Federal Aviation Administration
Aviation Rulemaking Advisory Committee

Aircraft Certification Procedures Issue Area
International Certification Procedures Harmonization Working Group

Task 2 – Type Certificated Products NPRM 97-7

Figure 2.1

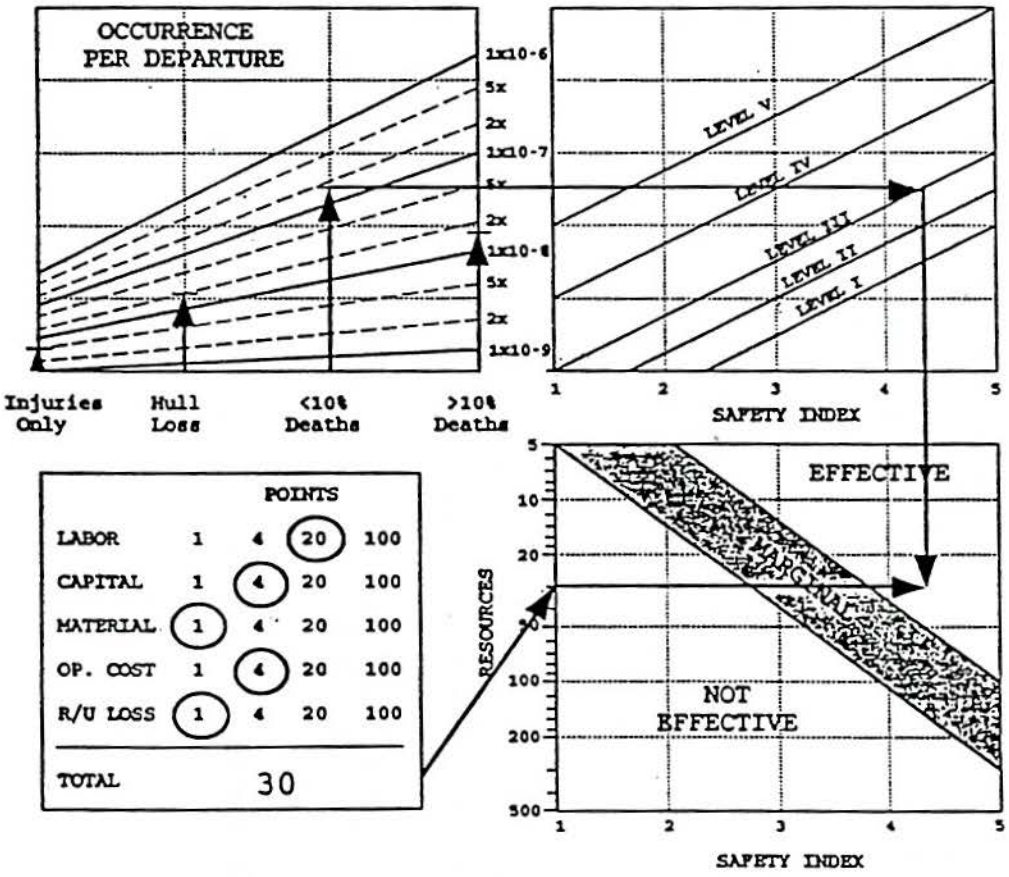
This commenter also provides specific recommendations to change Figure 2.1 so that the occurrence curve also applies to rotorcraft operations. In addition, the commenter recommends changing Table 2.1 to remove the middle column; and changing Table 2.2 to add wording to include qualification costs in the "Labor" row. The commenter also recommends changing the definitions of "labor" and "capital" in the "Terms used in Table 2.2" chart. The recommended changes would be to include the word "test" in the labor definition (after "inspection") and include the word "testing" in the capital definition (after "design").
